## CITY OF ALBUQUERQUE

RE: Tract A-3-B (Legacy at Journal Center) 5151 Lang Ave NE Request for Certificate of Occupancy – Permanent Hydrology Final Inspection - Disapproved Engineer's Stamp Date 4/26/17 (D17D106A) Certification Dated: 10/12/17

C-100

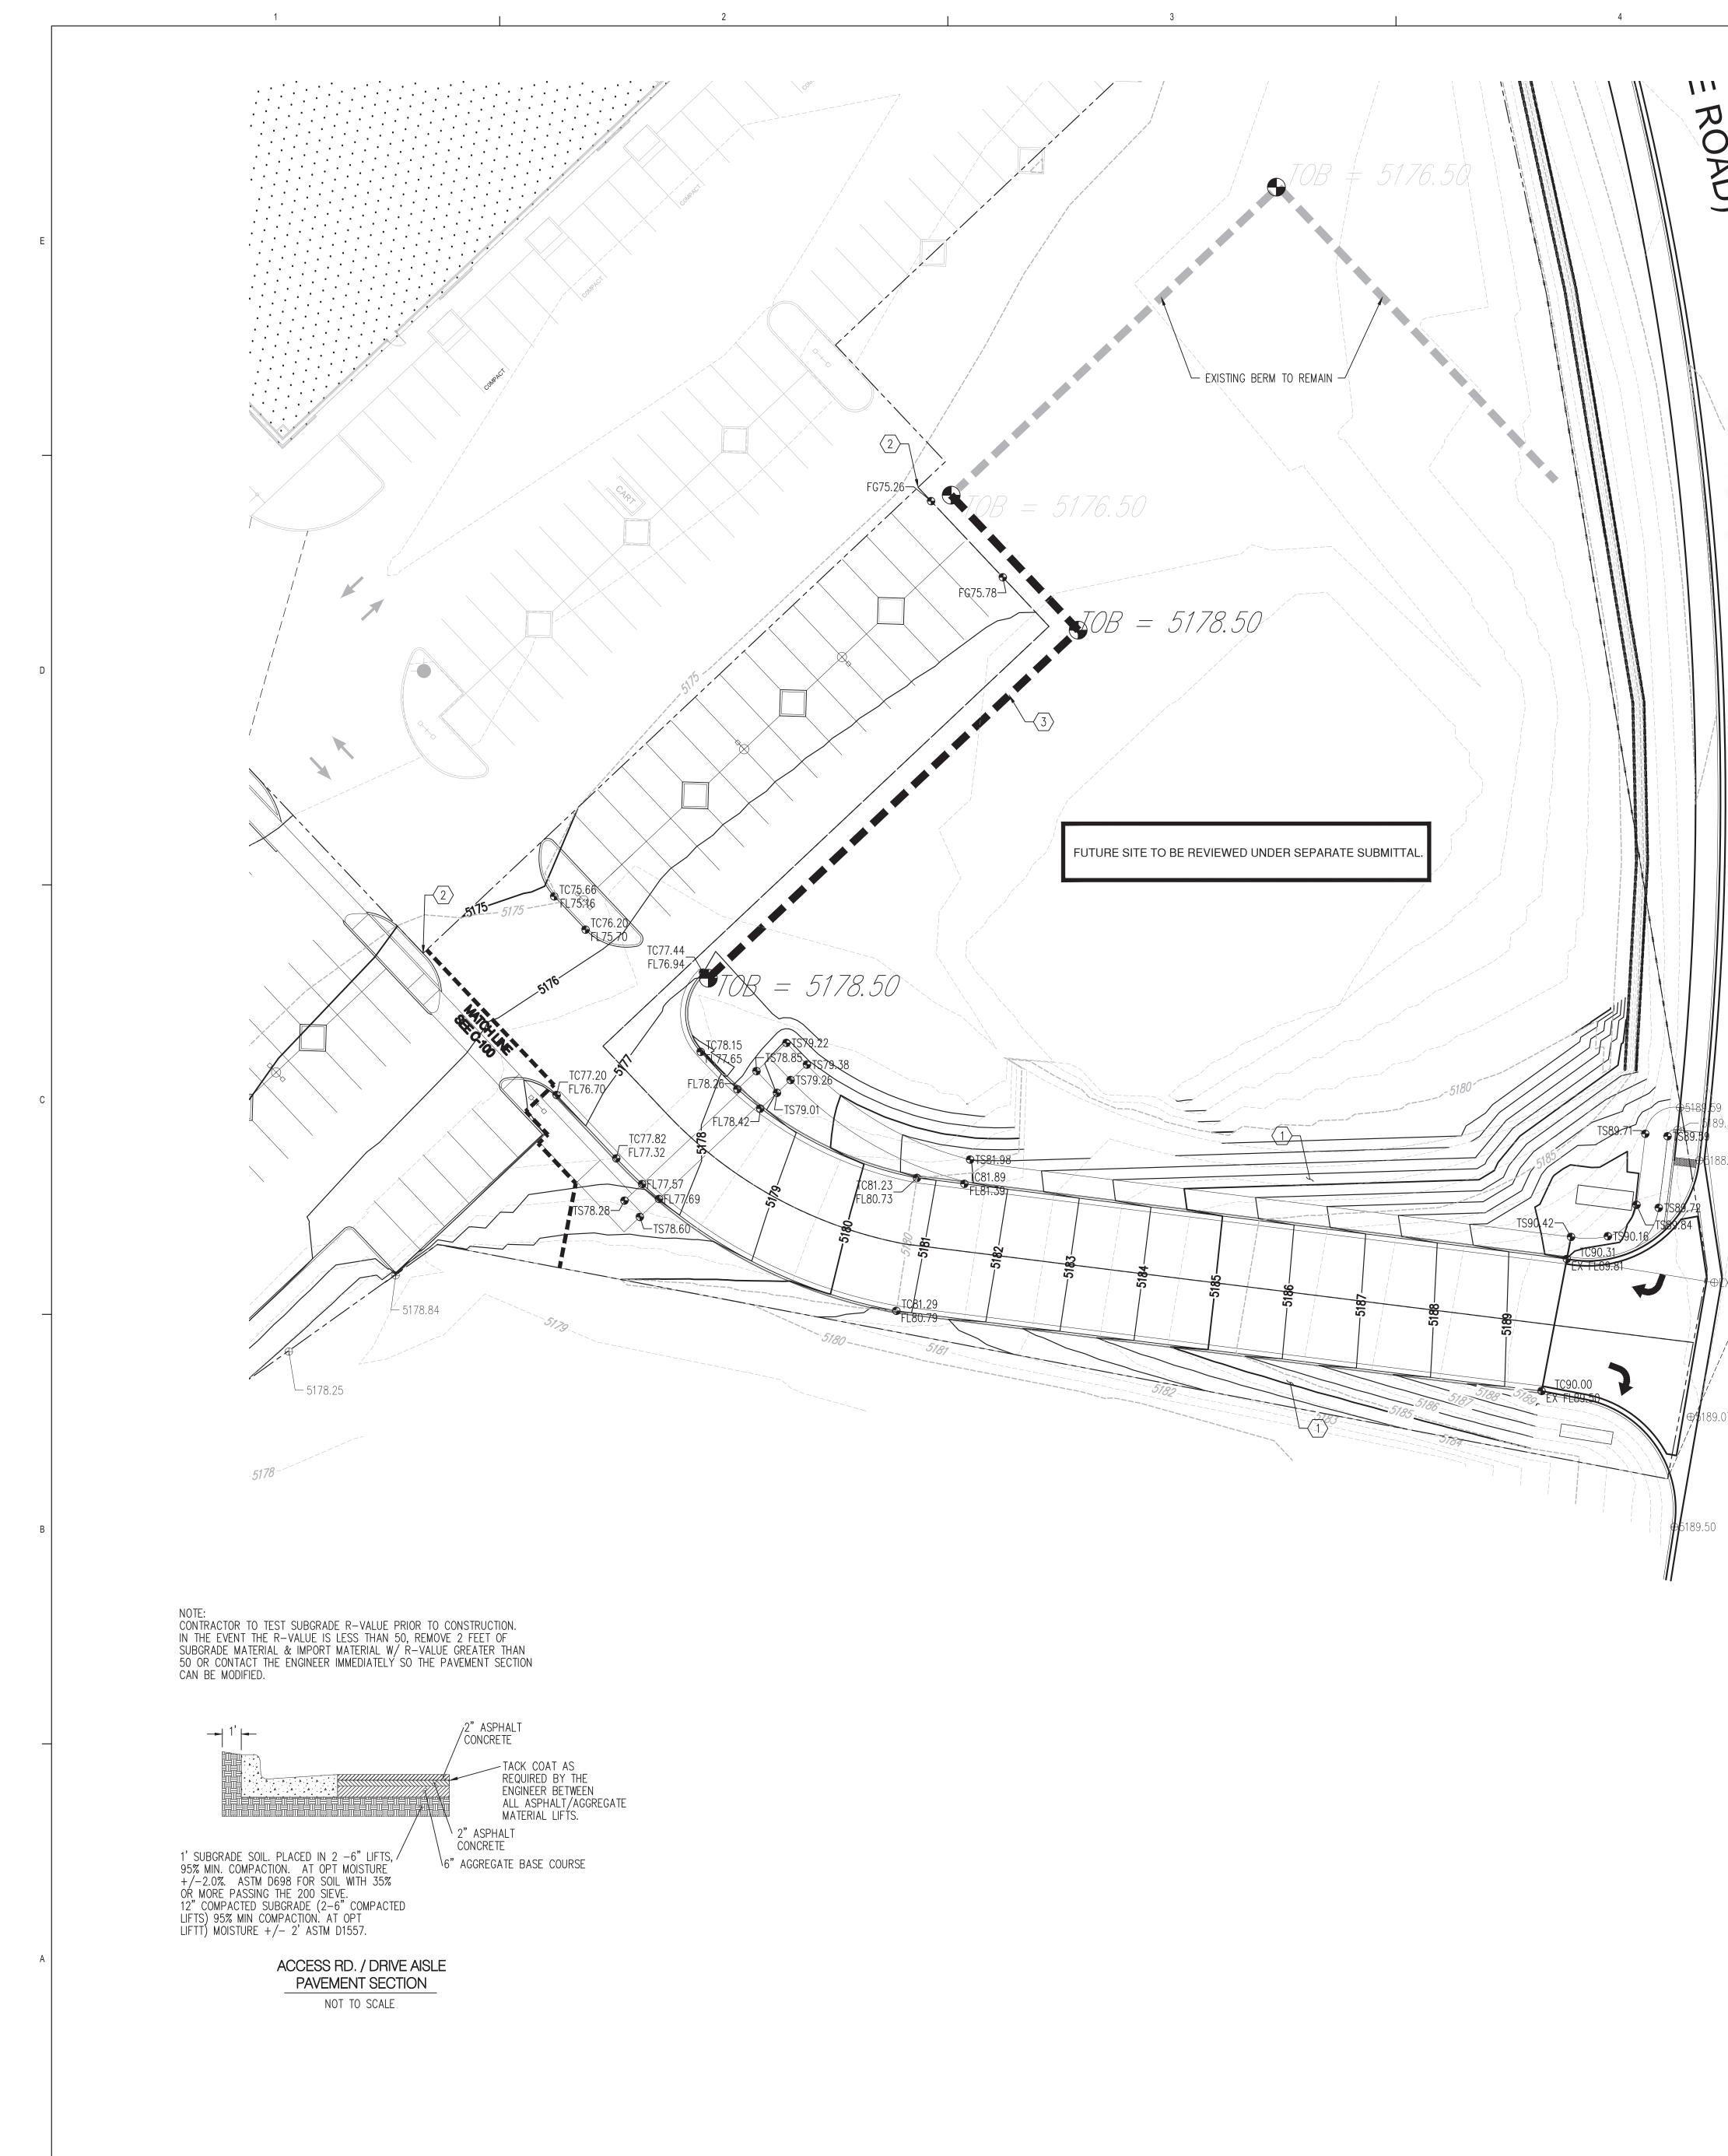
6. The survey information needs to be edited (As-Built) into the original grading plan, not

8. The temporary sediment control berm is not constructed. This needs to be as-built as such. Discussing with Curtis Cherne, the berm is not critical as long as the silt fence remains in

attached.

good condition.
